Wisconsin Department of Transportation

Proposal #03: 1000-57-70, FR-CRS-0068-2
Milwaukee Airport 2nd Platform
RR Crossing 393023R to 1200 FT South
STH 119
Milwaukee County

This is Addendum No. 01, which provides for the following:

ADDENDUM NO. 01
PROJECT ID 100-57-70
March 30, 2023

FOUNDATION PLAN

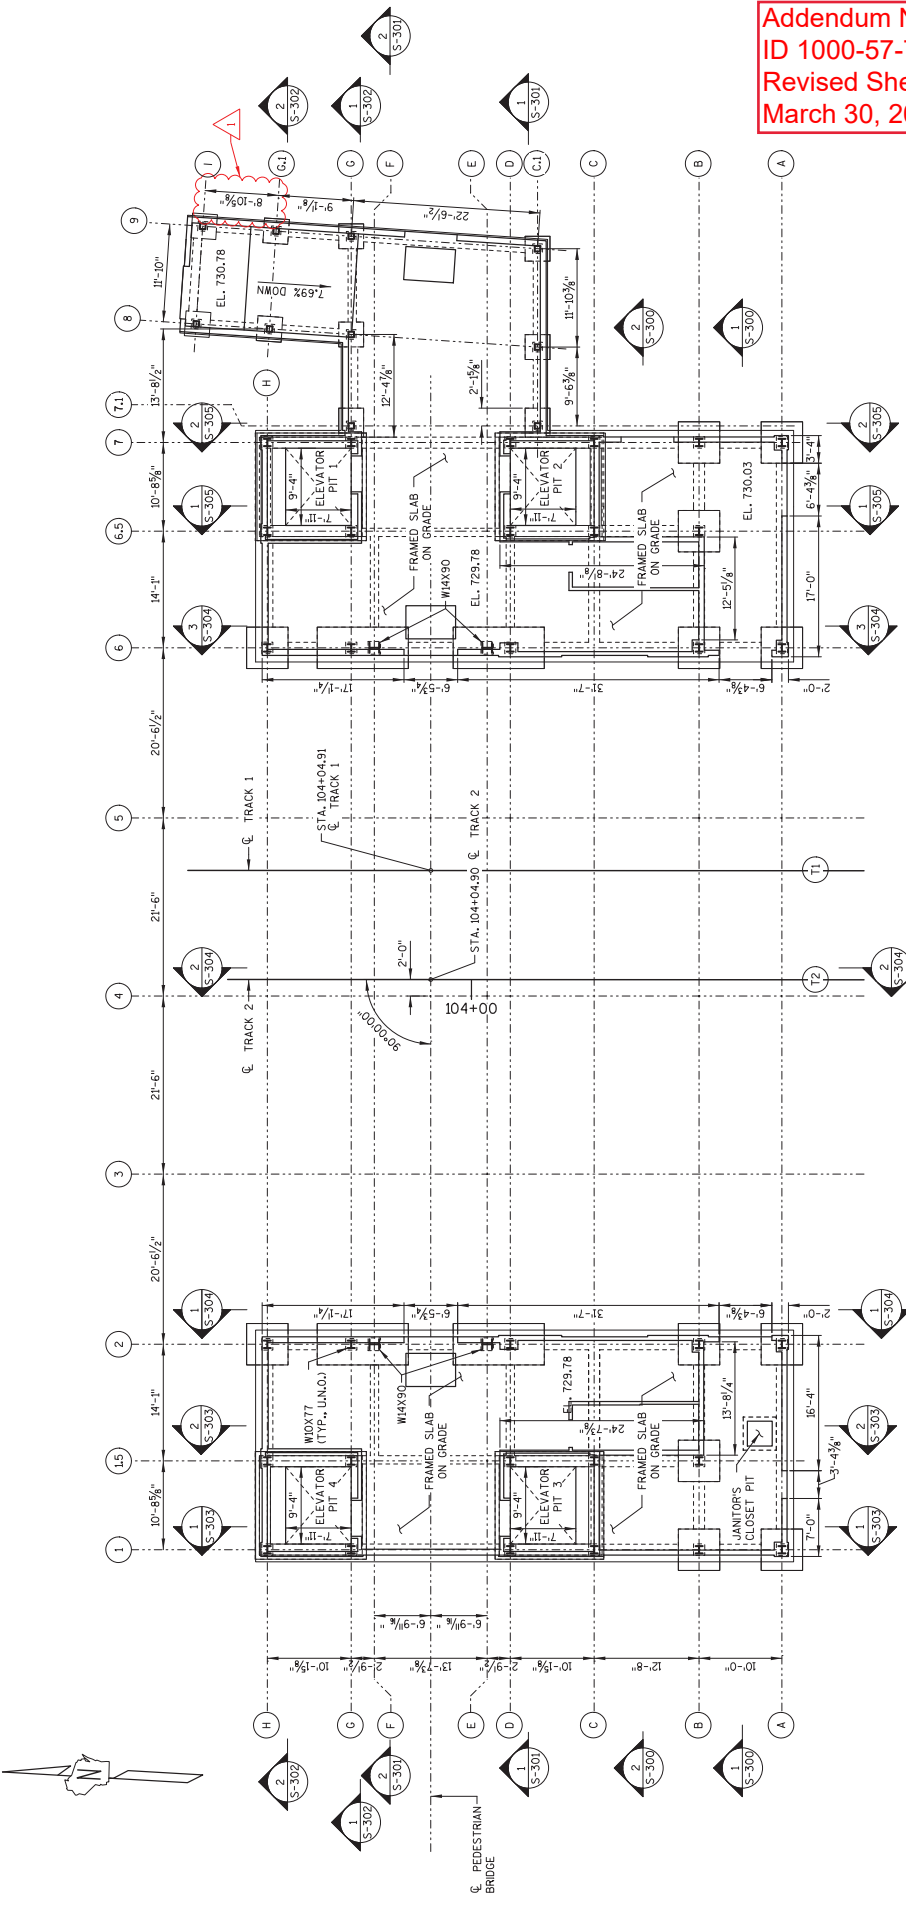
Revised Plan Sheets	
Plan Sheet	Plan Sheet Title (brief description of changes to sheet)
2	Sheet Index: Sheets A-530 & A-531 were added
58	S-100 Foundation Plan (Dimensions)
59	S-101 Platform Level (Dimensions)
60	S-102 Intermediate Level (Dimensions)
90	S-517 Building Foundation Details Type 3 (Dimensions)
95	S-522 Grade Beam Reinforcement Plan (Dimensions)

NO.	DATE	REVISION	BY
1	3/27/23	DIMENSIONS	DNU

1. PLATFORM LEVEL
S-101 NTS

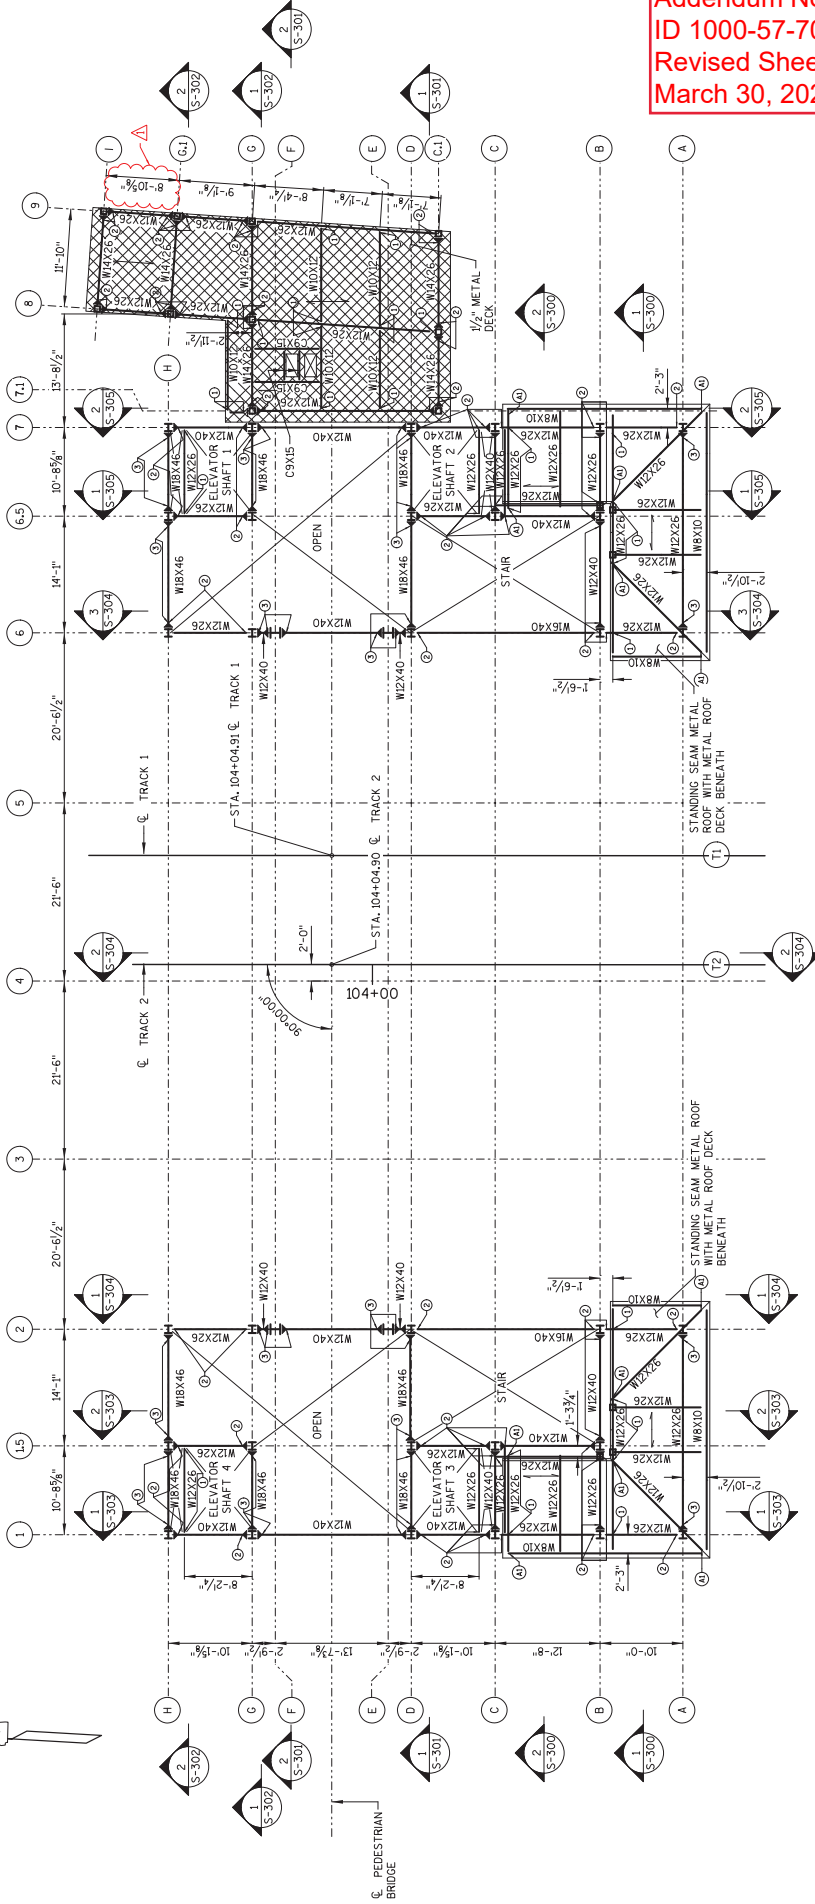
NO.	DATE	REVISION	BY
1	3/27/23	DIMENSIONS	DNJ

1 INTERMEDIATE LEVEL
 NTS

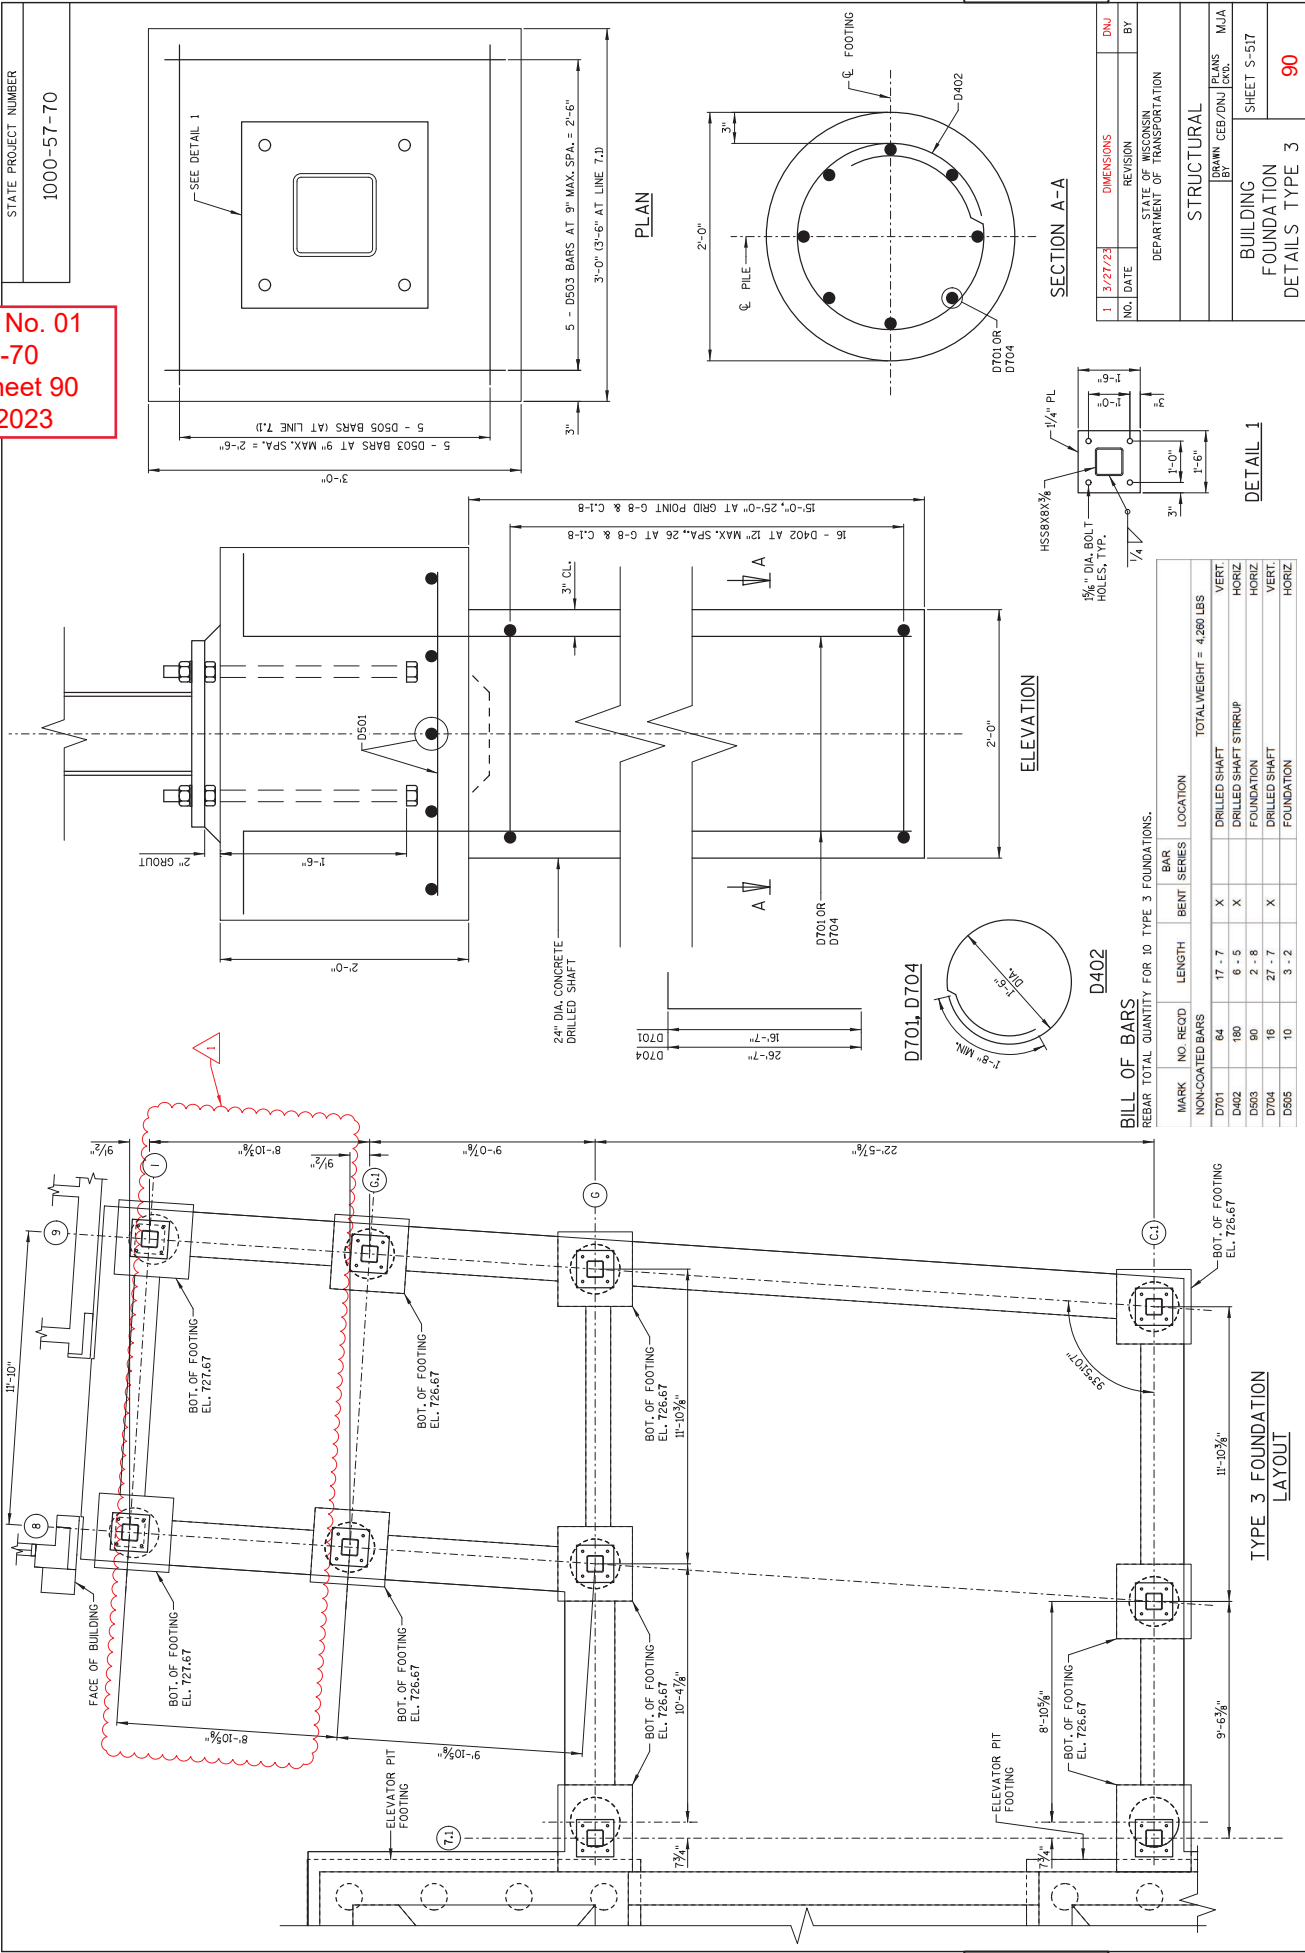
NO.	DATE	REVISION	BY
1	3/27/23	DIMENSIONS	DNU
STATE OF WISCONSIN DEPARTMENT OF TRANSPORTATION			
STRUCTURAL			
BY: JAWNS, CEB/DNU/CCK/MJA			
SHEET S-102			
INTERMEDIATE LEVEL			
60

GRADE BEAM REINFORCEMENT PLAN

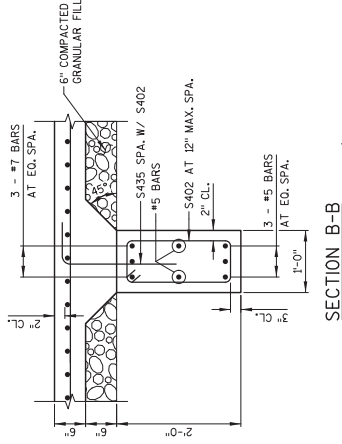
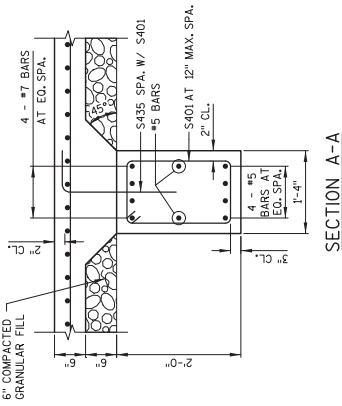
NO.	DATE	REVISION	BY
1	3/27/23	DIMENSIONS	DNJ

NO.	DATE	REVISION	BY
1	3/27/23	REVISED FIRE RATED WALLS	JR
STATE OF WISCONSIN DEPARTMENT OF TRANSPORTATION			
ARCHITECTURAL			
DRAWN BY: JR		PLANS CKD: DK	
EGRESS PLANS AND CALCULATION		SHEET G-003	
		103

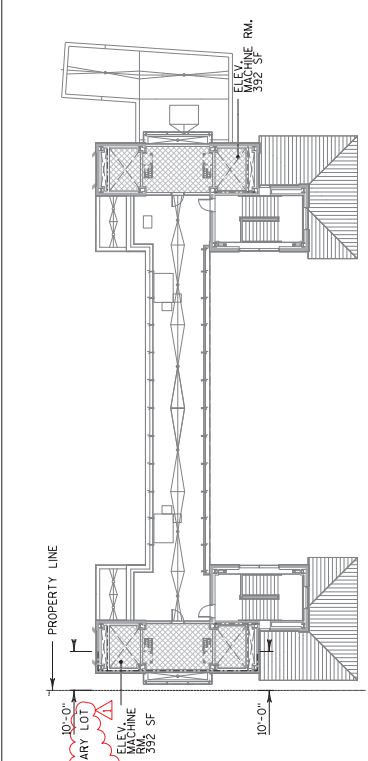
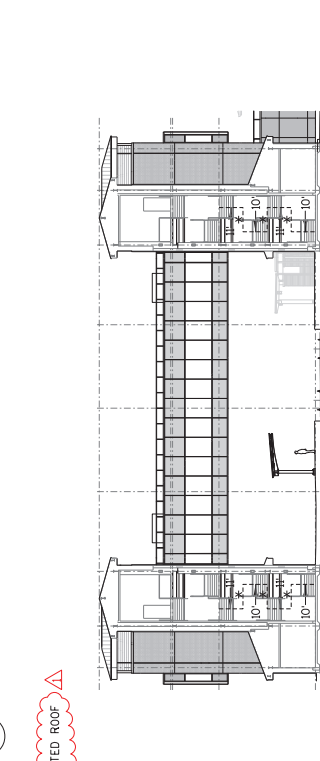
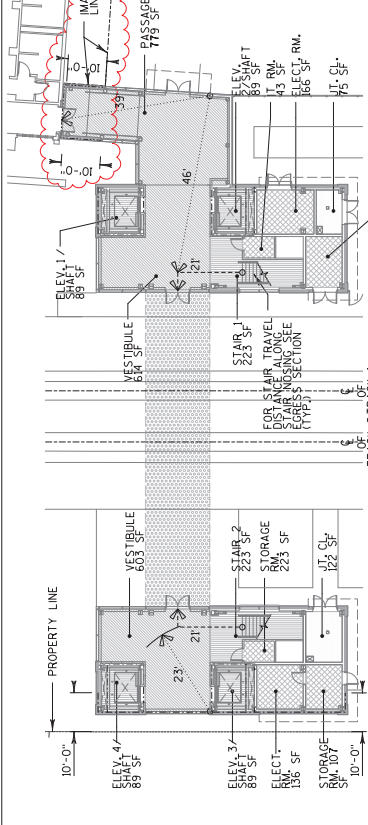
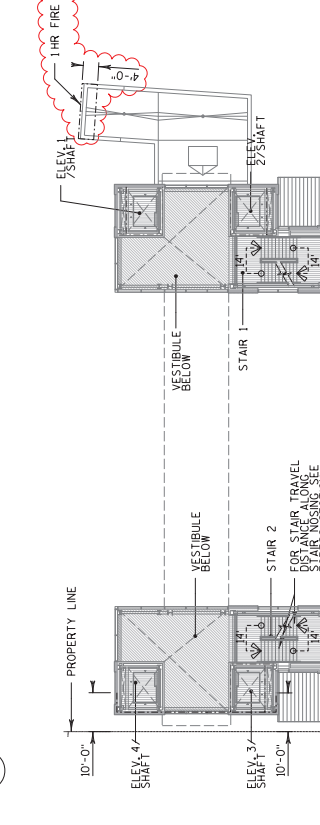
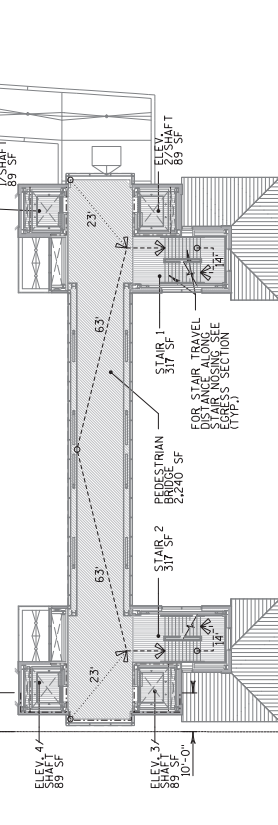
102	G-002 Added tables 8, 9, 10, and 11. Revised occupancy group for rooms 109 and 111 on table 2.
103	G-003 Revised fire rated wall on 1 st floor egress plan and fire rated roof on Int. level egress plan.
114	A-111 Added existing restroom and existing drinking fountain to existing building. Revised location of grid line "I" and revised passage's walls and store fronts.
115	A-112 Revised location of grid line "I" and revised passage's parapet walls.
119	A-120 Revised location of grid line "I" and revised reflected ceiling plan
126	A-201 Revised Note
127	A-202 Revised east elevation at East Tower
130	A-303 Revised keynotes
131	A-304 Revised keynotes
132	A-305 Revised keynotes
133	A-306 Revised elevations and partial plan
143	A-402 Revised Passage's walls, dimensions, and reference numbers.
145	A-404 Revised parapet wall.
154	A-502 Removed detail 9/A-502 replaced with modified detail 10/a-502. Detail 10/A-502 replaced with 11/A502 and detail 12/A-502 renamed to 11/A-502.

INTERMEDIATE LEVEL CONSTRUCTION PLAN
SCALE: 1/8"=1'-0"

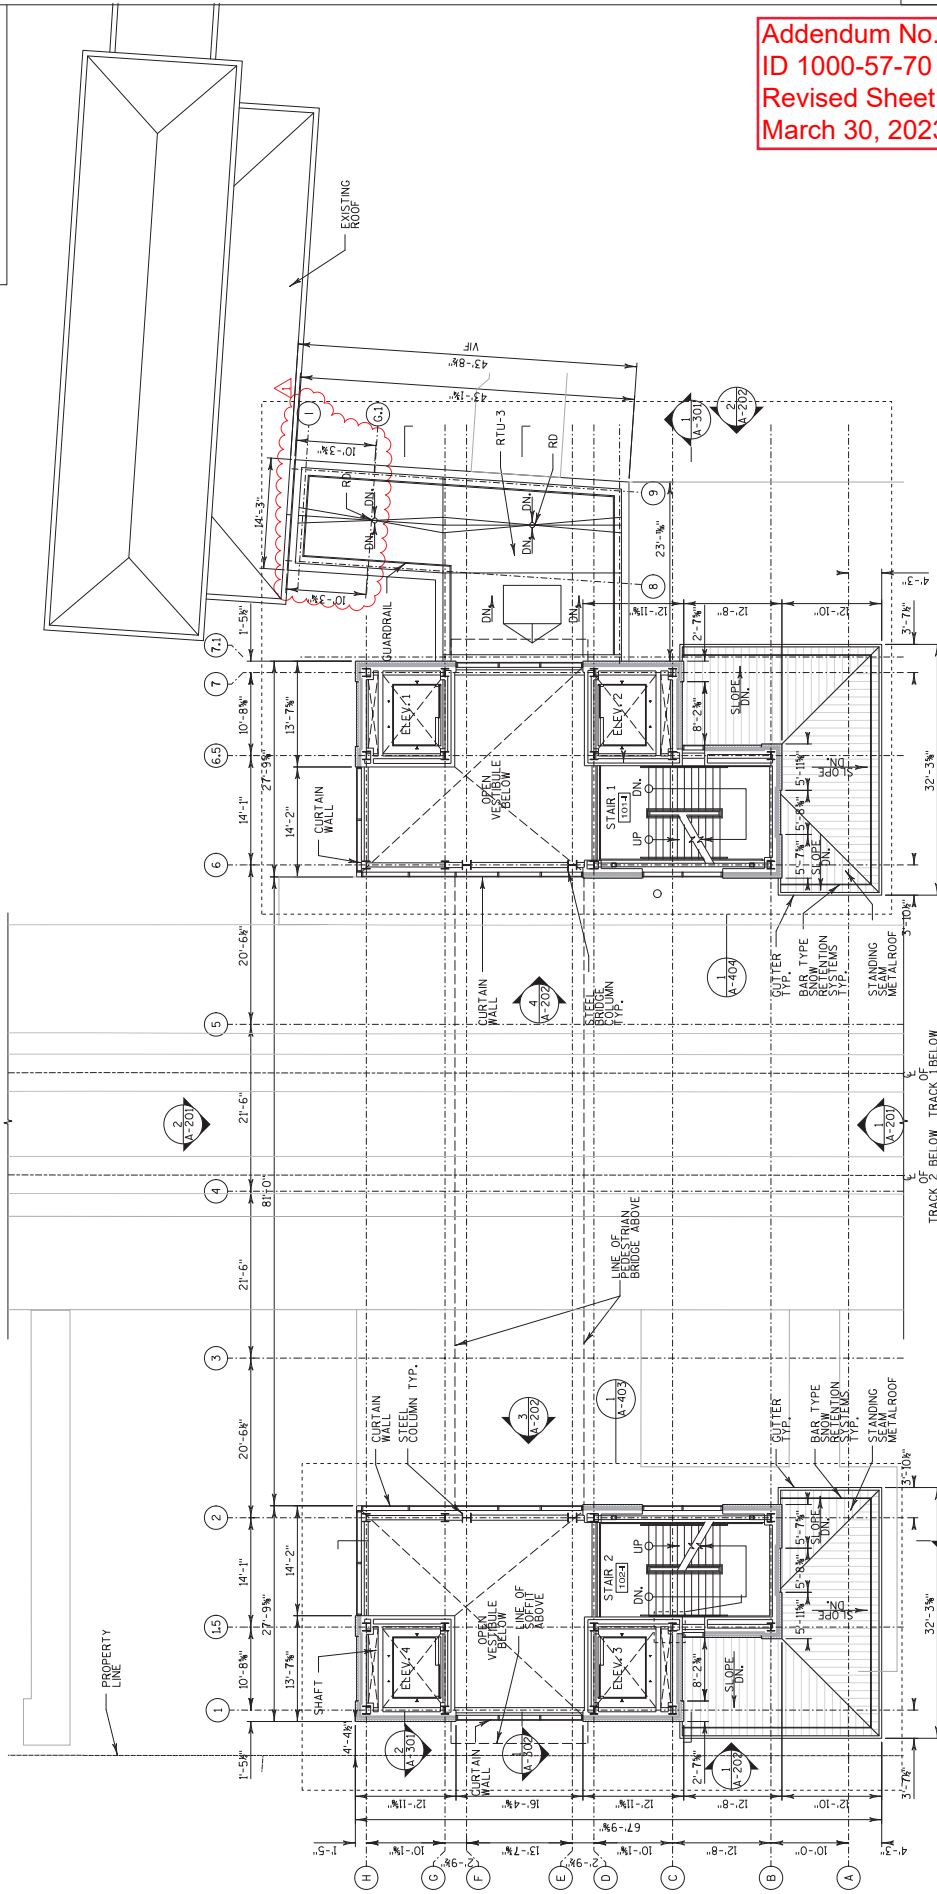
NO.	DATE	REVISION	BY
1	3/27/23	ROOF PARAPET	JR

ENLARGED FIRST FLOOR CONSTRUCTION PLAN

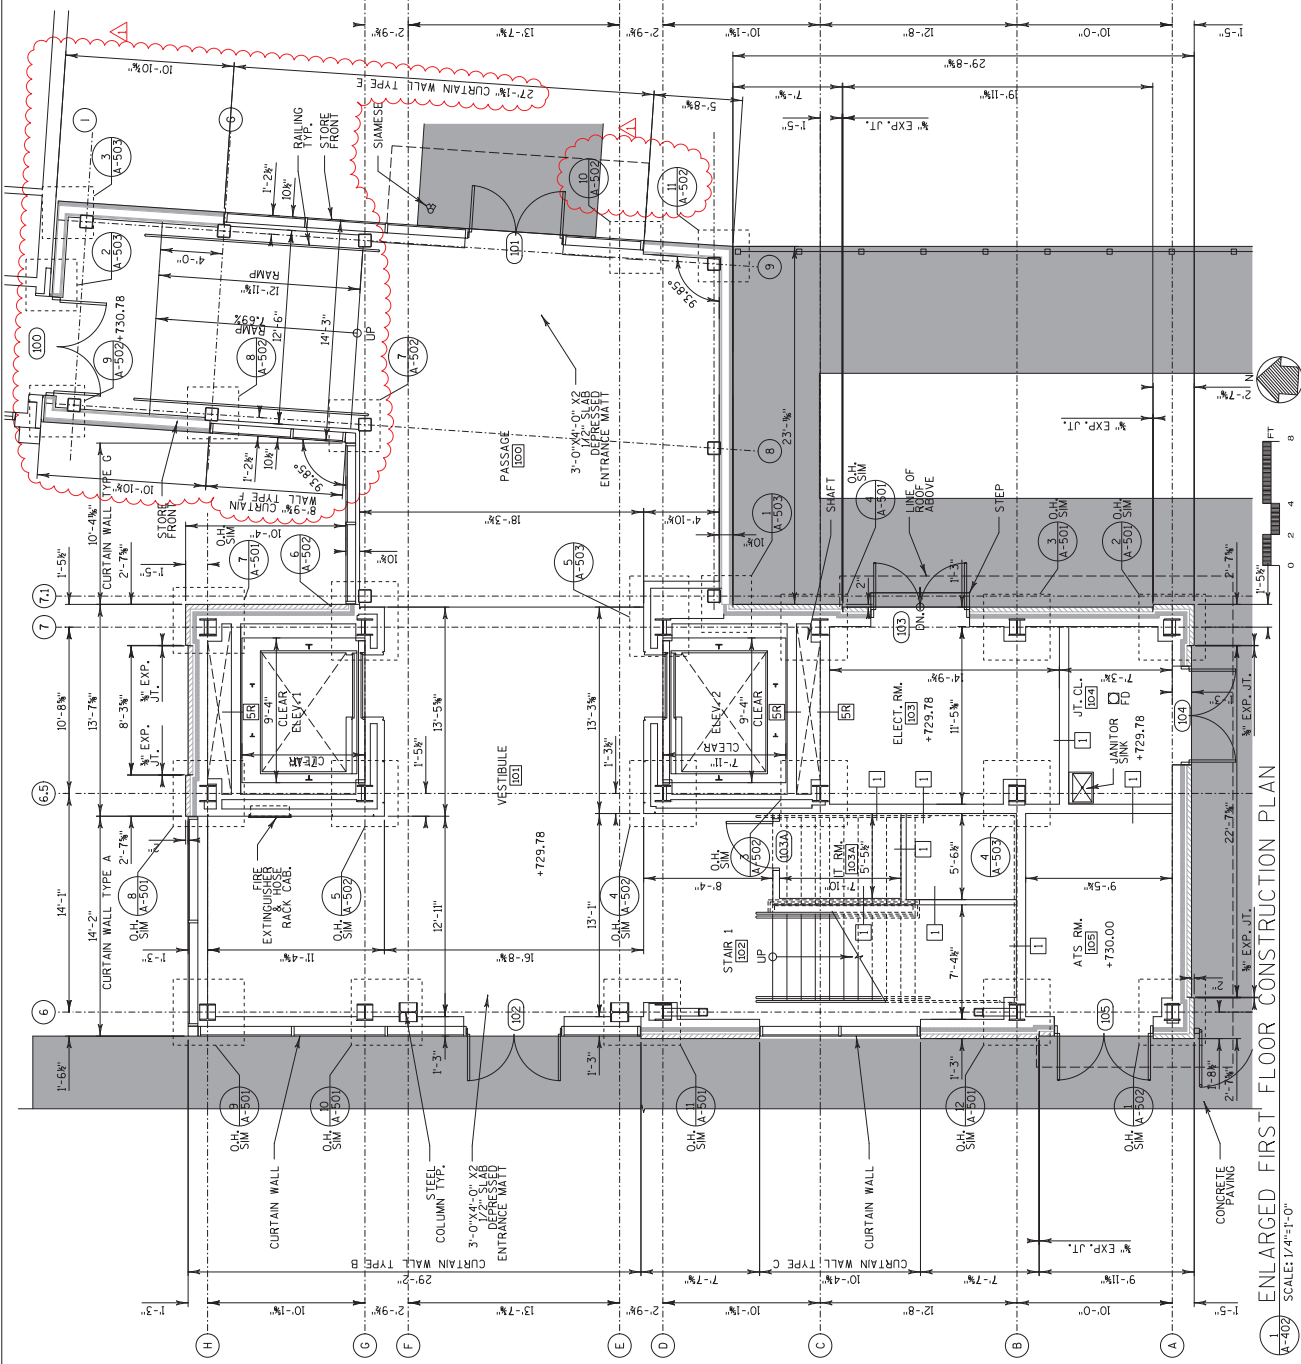
1	3/27/23	PASSAGE WALL AND DIMENSIONS	JR
NO.	DATE	REVISION	BY
STATE OF WISCONSIN DEPARTMENT OF TRANSPORTATION			
ARCHITECTURAL			
DRAWN BY: JR			
CHECKED BY: DK			
SHEET A-402			
CONSTRUCTION PLAN			
143
